DESIGN <i>[Signature]</i>	DRAWN BY <i>CP</i>	<b>DART AEROSPACE LTD</b> HAWKESBURY, ONTARIO, CANADA	
CHECKED <i>[Signature]</i>	APPROVED <i>[Signature]</i>	DRAWING NO. DSI 9263	REV. A SHEET 1 OF 1
DATE 03.06.25		TITLE SPACER BLOCK KIT	SCALE NTS
A	03.06.25	NEW ISSUE

## **DART SERVICE INSTRUCTION**

**TO AMEND INSTALLATION INSTRUCTIONS IIN-D206-667 REV. A or B**

REF. CANADIAN STC: SH01-5

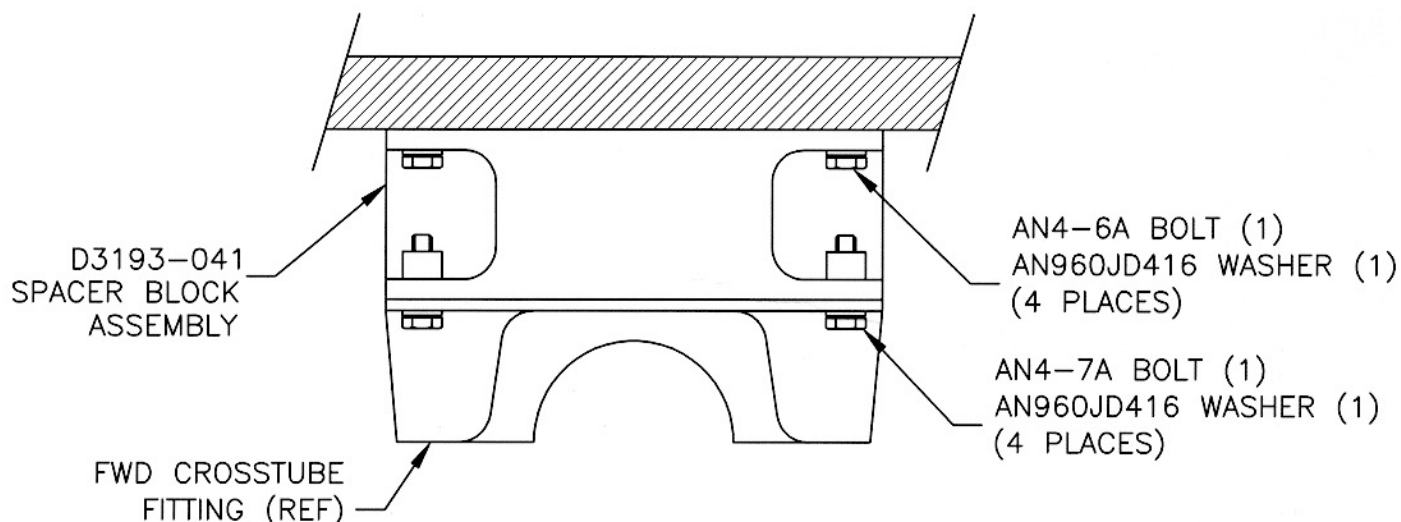
WHEN CONVERTING A 206 A/B AIRCRAFT FROM LOW TO HIGH GEAR BY INSTALLING D206-681-011 LANDING GEAR, THE D206-667-011 SPACER BLOCK KIT (OR EQUIVALENT) MUST BE INSTALLED BETWEEN THE FUSELAGE AND FWD CROSSTUBE FITTINGS BEFORE INSTALLING THE LANDING GEAR ON THE AIRCRAFT.

QTY -011	Part Number	Description
X	D206-667-011	SPACER BLOCK KIT
8	AN4-6A	BOLT
8	AN4-7A	BOLT
16	AN960JD416	WASHER
2	*D3193-041	SPACER BLOCK ASSEMBLY

\* OR AA P/N 206-321-005 OR BHT P/N 206-031-586-003
